ENGINE - LP COMPRESSOR - LPC BLEED DUCT WITH REDUCED 44 SQUARE INCHES EXIT THROAT AREA
- CATEGORY CODE 7 - MOD.ENG-72-0044

V2500-ENG-72-0044

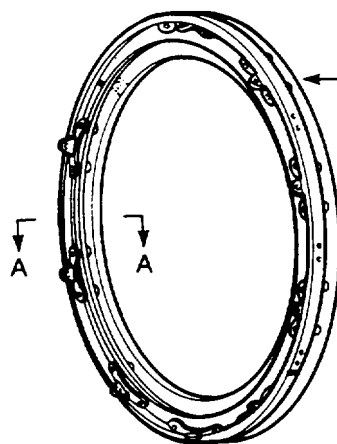
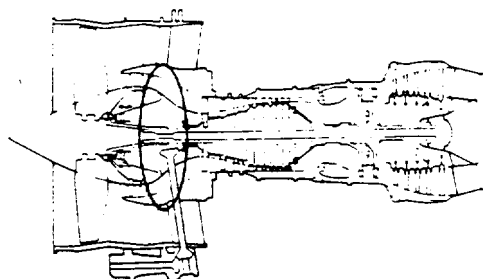
- (1) Rewire jumpers of 5A9298 Data entry plug assembly in accordance with the wiring requirements for 5A0357, Reference (2), Chapter/Section 71-00-00 Testing-11.

NOTE: Do not change the data on 5A9298 data entry plug assembly when jumpers are rewired in accordance with the wiring requirement for 5A0357. Rewiring is necessary for only the engine rating data.

- (a) Read the engine rating data from 5A9298 Data entry plug assembly.
- (b) Rewire jumpers for the engine rating data in accordance with wiring rule for 5A0357 Data entry plug assembly.

Replacement of LPC bleed duct assembly
Fig.1

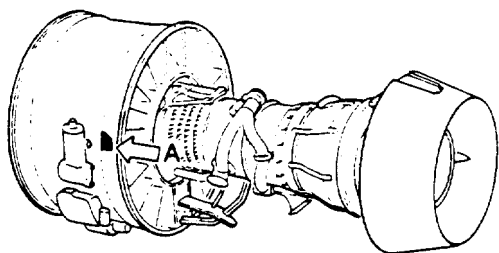
REMOVE PN 5W2038 AND
INSTALL PN 5W2080 LPC
BLEED DUCT ASSEMBLY

PN 5W2038

PN 5W2080

- (1) Install the 5W2080 LPC bleed duct assembly by the approved procedure in Reference (2), Chapter/Section 72-32-00 Assembly, Figure 1.
- (2) Reidentify 5W0016 LPC/Intermediate case module as 5W0102 LPC/Intermediate case module by the approved procedures in Reference (4), Chapter/Section 70-09-00, Marking of Parts, Figure 2. Use blank 5A2189 Module identification plate (72-32-85, 03-100) and translate the data from existing Module identification plate except the module part number, if necessary.

Reidentification of the LPC/intermediate case module and the EEC program plug identification
Fig.2

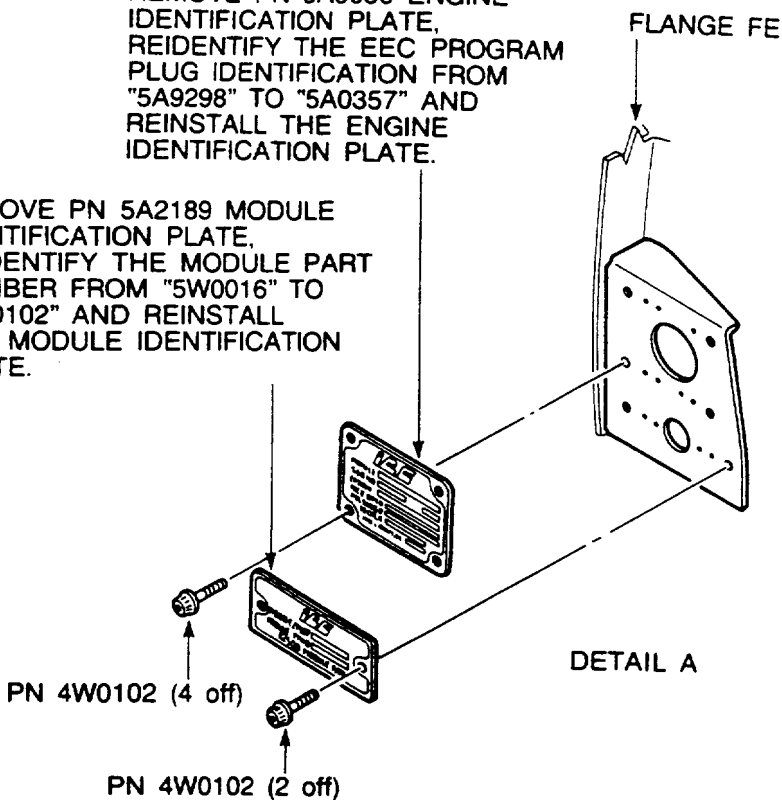
REMOVE PN 5A9036 ENGINE IDENTIFICATION PLATE, REIDENTIFY THE EEC PROGRAM PLUG IDENTIFICATION FROM "5A9298" TO "5A0357" AND REINSTALL THE ENGINE IDENTIFICATION PLATE.

REMOVE PN 5A2189 MODULE IDENTIFICATION PLATE, REIDENTIFY THE MODULE PART NUMBER FROM "5W0016" TO "5W0102" AND REINSTALL THE MODULE IDENTIFICATION PLATE.

- (3) Reidentify the EEC program plug identification on 5A9036 Engine identification plate (72-32-85, 03-120).
 - (a) Reidentify the EEC program plug identification from "5A9298" to "5A0357" by the approved procedures in Reference (4), Chapter/Section 70-09-00, Marking of Parts, Figure 2. Use blank 5A9036 Engine identification plate (72-32-85, 03-120) and translate the data from existing Engine identification plate except the EEC program plug identification number, if necessary.
